STAFF REPORT: 9/13/2023 REGULAR MEETING

APPLICATION NUMBER: #23-8523

ADDRESS: 4325 FULLERTON

SCOPE: REMOVE WINDOWS (WORK COMPLETED WITHOUT APPROVAL), INSTALL ALUMINUM CLAD WOOD WINDOWS

Site Photo 6, by Applicant, showing vinyl cover arch over vinyl window pair, located over the side entrance.

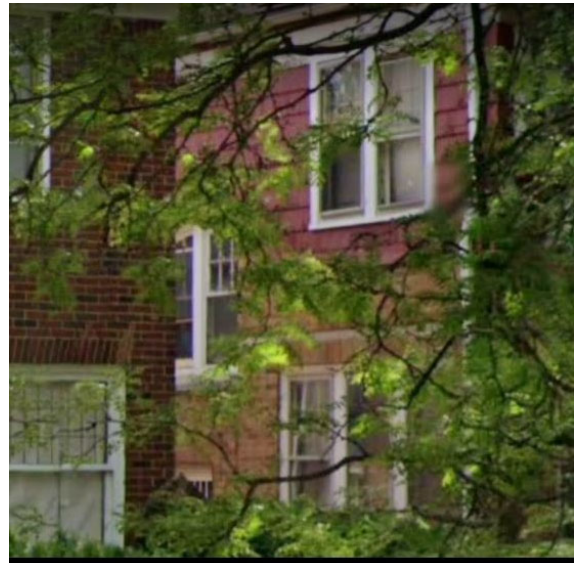
- Staff observed that above the side entrance (east elevation), a pair of double hung windows with a curved top rail were replaced with a pair of rectilinear vinyl windows with what appears to be a vinyl cover at the remaining arch of the former windows. It is staff's opinion that this pair of windows is a distinctive character defining feature that was altered without approval. Vinyl is not an appropriate material in the Russell-Sullivan Historic District, given its inability to faithfully replicate historic profiles, its detracting color/sheen, and its poor detailing. Staff also observed that this pair of windows were missing from the window schedule, but present as double-hung rectangular windows in the window order. Staff received an update from the applicant, which states that the window order will be updated later to include this window pair, as arched upper railings, which has not been received at the time of this staff report. *(See Site Photos 5, 6 & 7.)*

- It is staff's opinion that the removal of the original arch over the east elevation window and proposed replacement with a vinyl cover alters the original *scale*, *design*, and *materiality* and that is incompatible and inappropriate for this historic property, and therefore does not meet the Secretary of the Interior's Standards for Rehabilitation and Elements of Design.

- The applicant provide HDC staff with the dimensions and description of method to install the windows and restore the brick moulding of the window openings.
- The applicant provide 6/1 simulated divided lites, 4/1 for the two smaller bathrooms.
- The east elevation vinyl windows be removed and replaced with an appropriate curved top rail design with double-hung, aluminum clad wood or wood windows and a 6/1 configuration.
- The applicant provide a window trim color selected from Color System D of the HDC color chart guidelines.
- HDC staff shall review and approve these submissions before their application/installation.
